#2 Belt Conveyor Disturbed area expansion TS-13 & TS-5 amendment Submittal,  
Castle Valley Mining, LLC, C/015/0025

**Title:** TS-5 & TS-13 Amendment

**Modify TS-13 & commit to coal clean up on TS-5**

SCALE: 1" = 50'  
 DRAWN BY: J.JORGENSEN  
 DATE: 8-7-2019  
 BEAR CANYON PLATE 2-3F

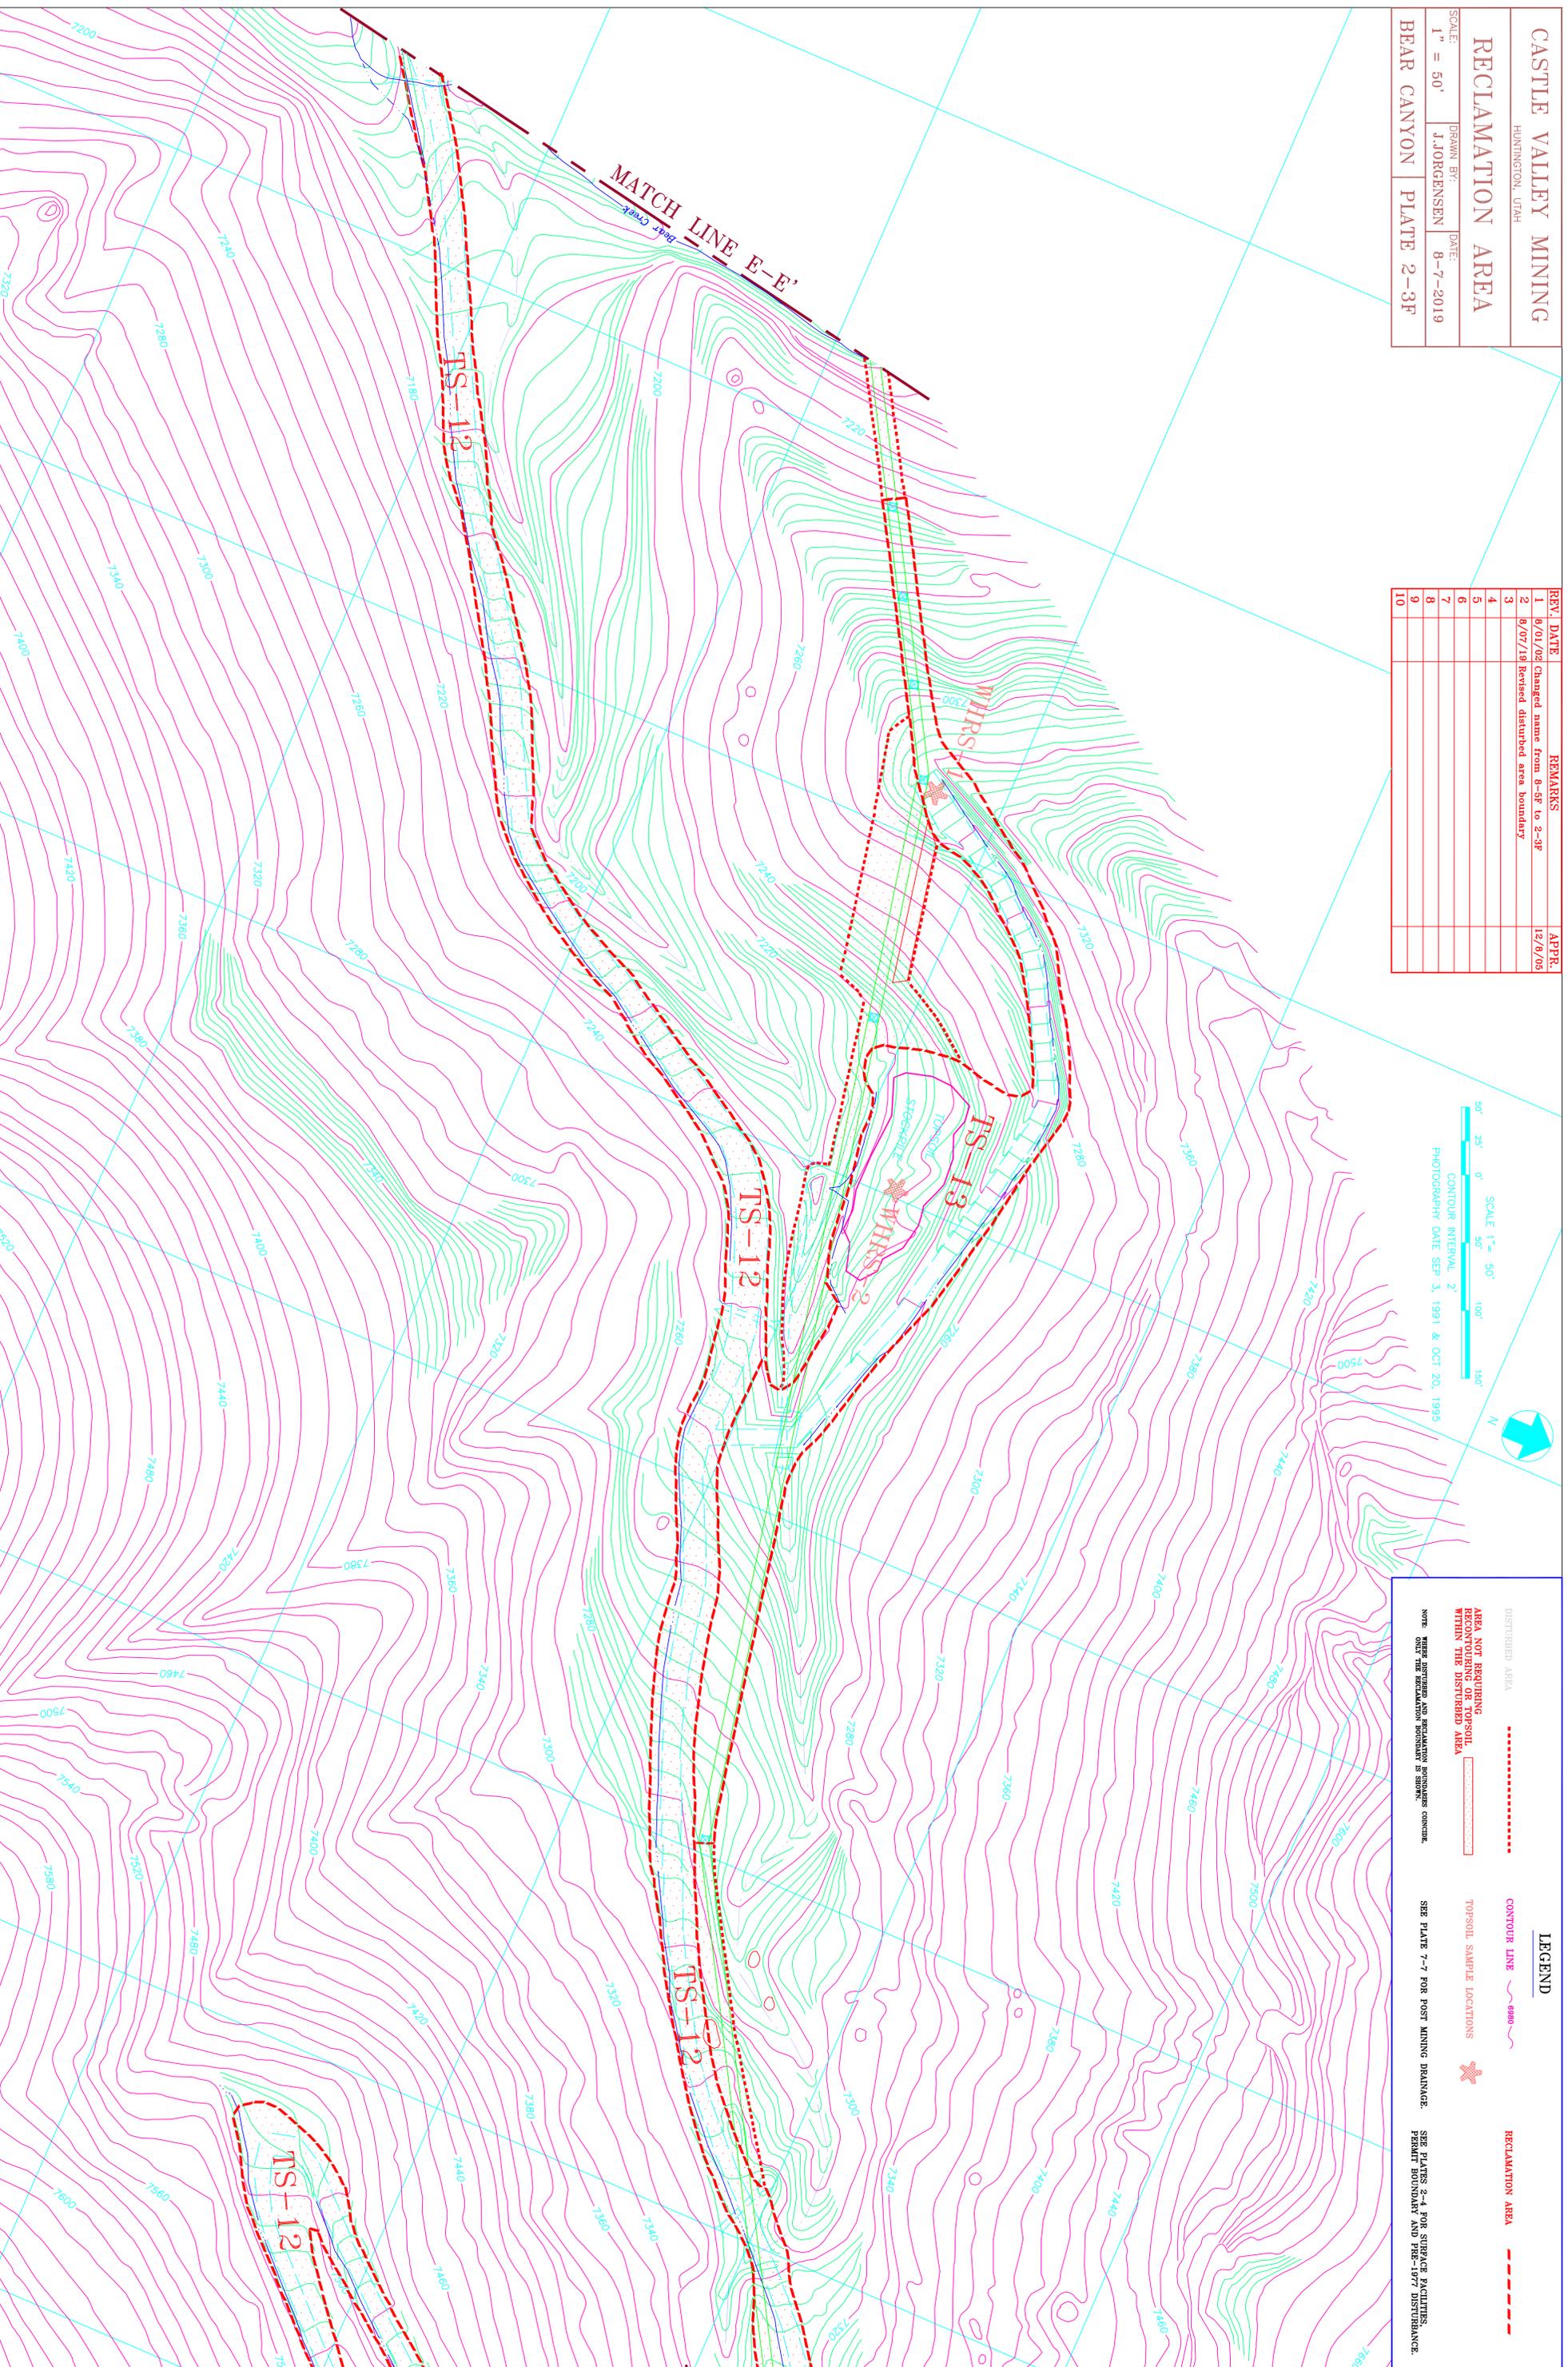
#1- Our #2 Belt conveyor will periodically spill when it gets overloaded. CVM is committed to keeping coal spillage cleaned up every year and will continue as needed. Inspector recommendations from Steve Demzak and Priscilla Burton state that we need to contain the coal spillage. In this part of the amendment Chapter 2-41 and 2-42 need modification as well as Plates 2-3F & 5-2F(See Attachments).

This area modified 8-1-2019 to reflect the modification of an expansion of disturbed area boundary located on [Plate 2-3F](#). Belt conveyor spillage frequent in this area and will be cleaned up upon 4" or more coal spillage weather permitting. South side boundary line will be lined with

straw bales to contain any coal spillage. Area too steep to recover any topsoil. Straw wattles will be placed where needed on the slope to prevent erosion. This area including expansion will be revegetated upon final reclamation.

REV.	DATE	REMARKS	APPR.
1	8/01/02	Changed name from 8-5F to 2-3F	
2	8/07/19	Revised disturbed area boundary	
3			
4			
5			
6			
7			
8			
9			
10
